APPLICATION NO.	FILING DATE	FIRST NAMED INVENTOR	ATTORNEY DOCKET NO.	CONFIRMATION NO.
09/683,482	01/07/2002	Jia-Fam Wong	ADTP0028USA	2814

Office Action Summary

DETAILED ACTION

FIG. 9

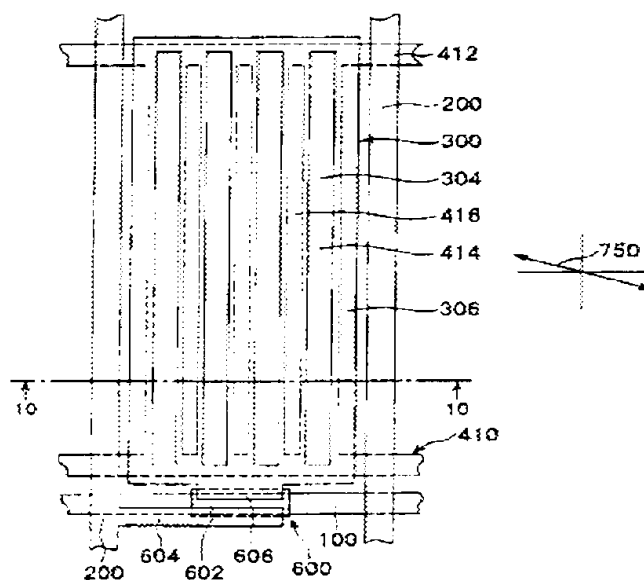
As to claim 1, Matsuyama discloses in Figures 9 and 10, third embodiment (col. 21, line 36 through col. 22, line 55), a liquid crystal display (LCD) comprising: a first substrate, 900, comprising a first surface; a second substrate, 800, comprising a second surface, the second surface being in parallel with and opposite to the first surface of the first substrate, and a pixel area being defined on the second surface; a second common electrode, 500 (Applicant's first electrode), positioned on the first surface of the first substrate; a first common electrode, 410 (Applicant's second electrode), disposed above the pixel region of the second substrate, the second electrode having side opening portions, 416 (Applicant's first slit) elongated along a first direction; an isolation

layer, 812, disposed on the surface of the second substrate to cover the second electrode; a pixel electrode, 300 (Applicant's third electrode), disposed on the isolation layer and within the pixel region, opening portions, 304 (Applicant's second slit), being defined on the third electrode and along the first direction, the first and second slits being interlaced (per Figures 9 and 10); and a plurality of anisotropic liquid crystal molecules with negative dielectric constant (Abstract) positioned between the first electrode and the third electrode, the longitudinal axis of the liquid crystal molecules being positioned along a second direction horizontally (Figure 3 and col. 21, lines 42-45), and a first angle being formed between the first direction and the second direction; wherein a biased electric field is formed as a voltage is applied between the first electrode and the second electrode, such that (a) a first horizontal biased electric field is formed in the neighborhood of the second slit (Figure 4), the first horizontal biased electric field is perpendicular to the first direction, and the liquid crystal molecules are rotated to make the longitudinal axis of the liquid crystal molecules in the neighborhood of the second slit being in parallel to the first direction, (b) the longitudinal axis of the liquid crystal molecules in the neighborhood of the first electrode maintain along the second direction because no horizontal biased electrical field is formed near the first electrode, and (c) the liquid crystal molecules between the first electrode and the second slit of the third electrode gradually rotate from the second direction to the first direction.
